August 2022 | Danfoss Climate Solutions for cooling

Cool Update

Solenoid Valve for Refrigeration Applications: ICF 20-2 to Replace EVRA(T) 10, 15 and 20

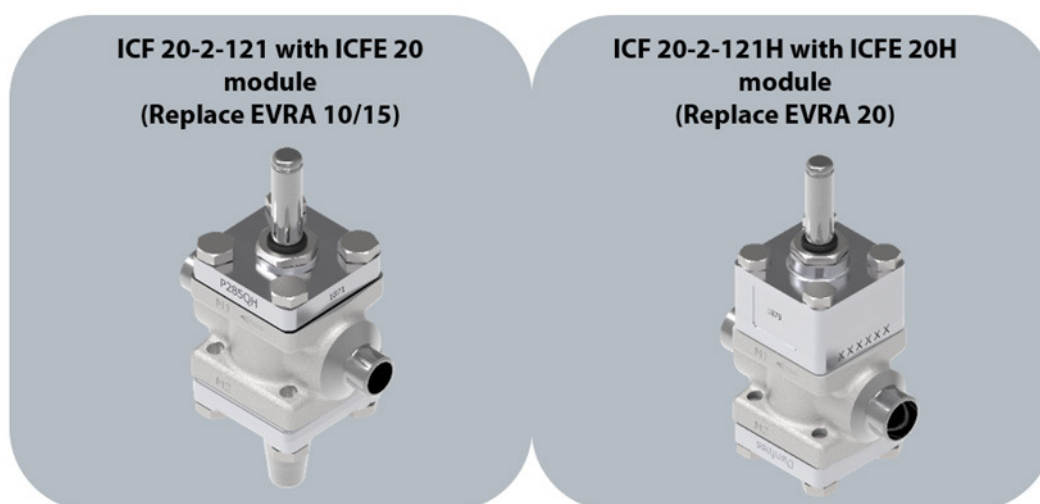
Danfoss has released ICF 20-2 solenoid valve that is specifically designed to replace EVRA 15, 20 and even size 10. It is a 1:1 replacement of EVRA 15 and 20 (10 will come later) but it will also open to the well-known flexibility of the ICF platform.

- Direct weld replacing flanges and gaskets increase safety and saves time
- Flat top cover gasket supports the use in systems down to -60°C and CO₂ up to 65 bar
- Serviceability and full flexibility with the ICF platform
- Manual opener becomes standard for both variants
- Many more refrigerants available since it is now based on the ICF platform (Please, see [Product store](#))
